2.0 Changes Since the Draft Environmental Impact Statement and Errata

Table 2-1. Draft EIS Errata

Figure 2-2. Project Footprint Changes

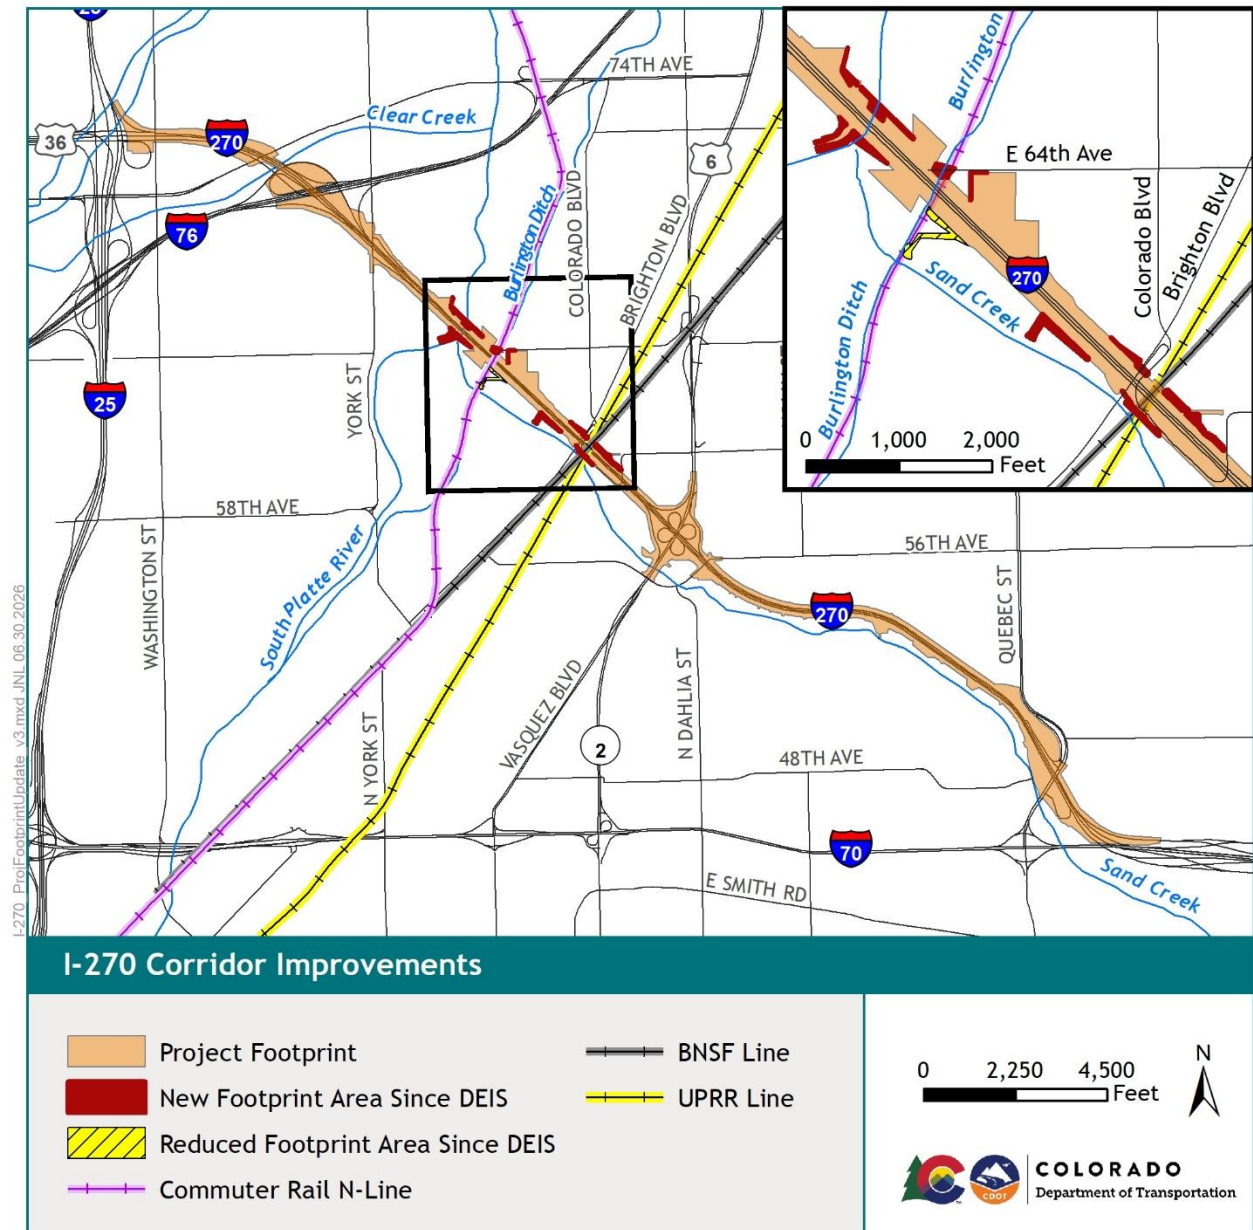
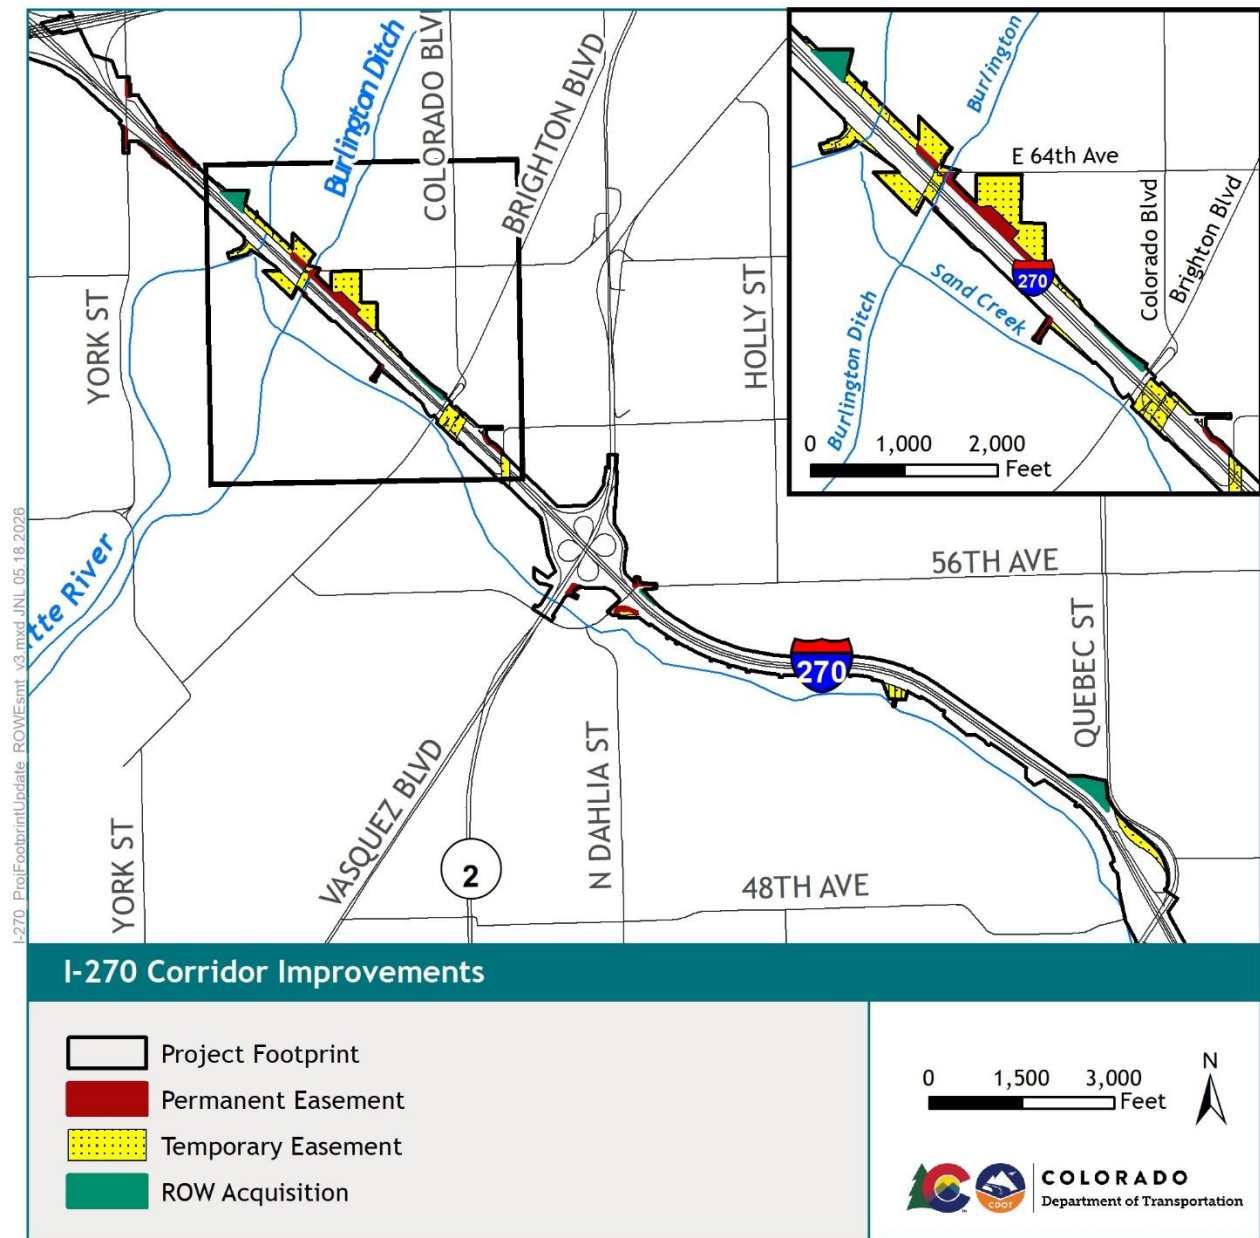
As a result of these design advancements, several minor adjustments to the project footprint were identified. These changes are shown in Figure 2-2 and summarized in the sections below.

- Construction Access and Temporary Easements.** Temporary easements were redefined to better support contractor access for constructing drainage improvements, trail relocations, riprap, and bridge/abutment elements. Shown in Figure 2-3, these include temporary access pads near the river, limited to work outside of the channel, with full restoration following construction. Temporary paths were refined to maintain public trail access during operating hours, with pedestrian bridges restricted to contractor foot access. Constraints were incorporated to avoid regrading irrigation maintenance access

roads (the service roads used by irrigation districts to operate and maintain their canals), to prevent heavy equipment use on the East 64th Avenue bridge, and to protect existing fences and utility assets. Temporary easements within the historic boundary were refined to minimize effects, to the extent practicable; however, some encroachments within the historic boundary remain.

- **Drainage, Stormwater, and Water Quality Improvements.** Since the Draft EIS, the design has been updated to include addition and refinement of permanent water quality treatment facilities, including a relocated water quality pond and associated maintenance access, refined water quality pond sizes, and a relocated storm sewer outfall. In addition, several locations along the South Platte River now incorporate riprap armoring to stabilize banks and meet updated hydraulic requirements.

- **Earthwork, Slope, and Retaining Features.** To meet geometric standards and minimize the overall footprint, the design includes refined toe of slope grading, localized retaining walls, and minor adjustments to embankments. These refinements address constructability constraints while avoiding additional impacts where feasible.

- **Bicycle, Pedestrian, and Local Access Elements.** At certain locations, sidewalk widening and trail reconstruction were incorporated to maintain safe and continuous pedestrian and bicycle connectivity during and after construction. These refinements reflect coordination with local jurisdictions and ensure consistency with community plans.

- **Corrections Based on Updated Survey and Field Verification.** In several locations, the permanent limits of disturbance were adjusted to match survey-verified right-of-way (ROW) or to provide adequate space for permanent drainage features. Minor shifts also accommodate utility protection, fencing adjacent to the N Line commuter rail corridor, and other site-specific needs identified during field reviews.
